DEPARTMENT OF TRANSPORTATION
STATE OF GEORGIA

SUBJECT APPROVED PROJECT CONCEPT REPORT

**Powder Springs Park and Ride Lot
Cobb County**

Project Number: MSL-0007-00(917)
PI No. 0007917
County: Cobb

STATE OF GEORGIA
 DEPARTMENT OF TRANSPORTATION
 OFFICE OF URBAN DESIGN
CONCEPT PLAN
 POMPHER SPRINGS
 PARK AND RIDE LOT
 DRAWING NO. CP

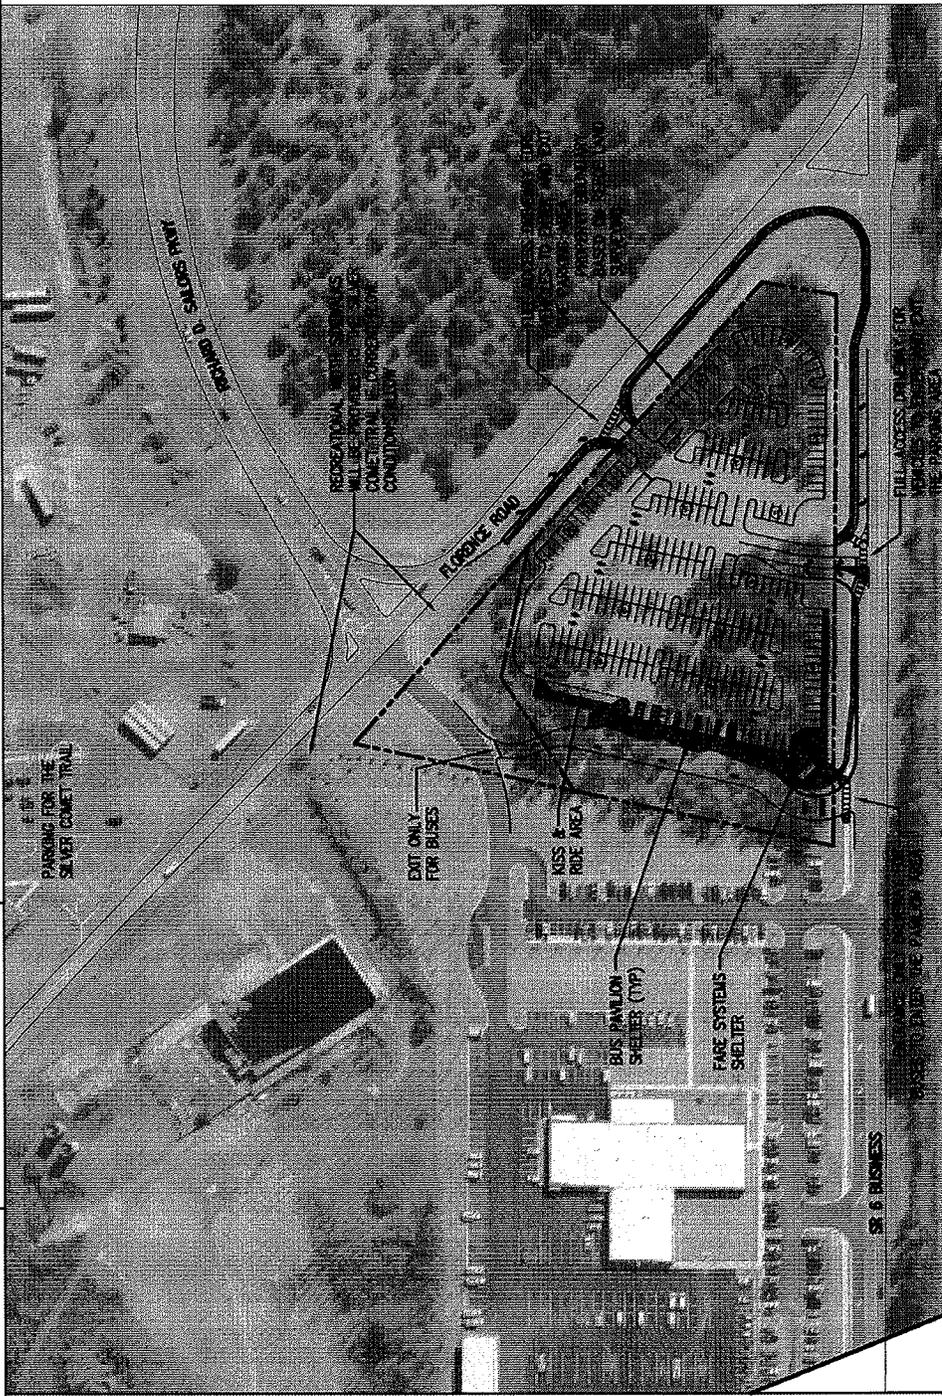
Comment: The deceleration lane for the bus access drive should be lengthened.

Comment: Curb and Gutter and sidewalks should be added on the Florence Road and Old Dallas Hwy (SR6) property frontage.

Comment: The existing right turn radius at Florence Road and Old Dallas Hwy (SR6) should be increased to accommodate buses.

Response: The concept plan will be revised to reflect this.

Response: The concept plan will be revised to reflect this.

Response: The concept plan will be revised to reflect this.
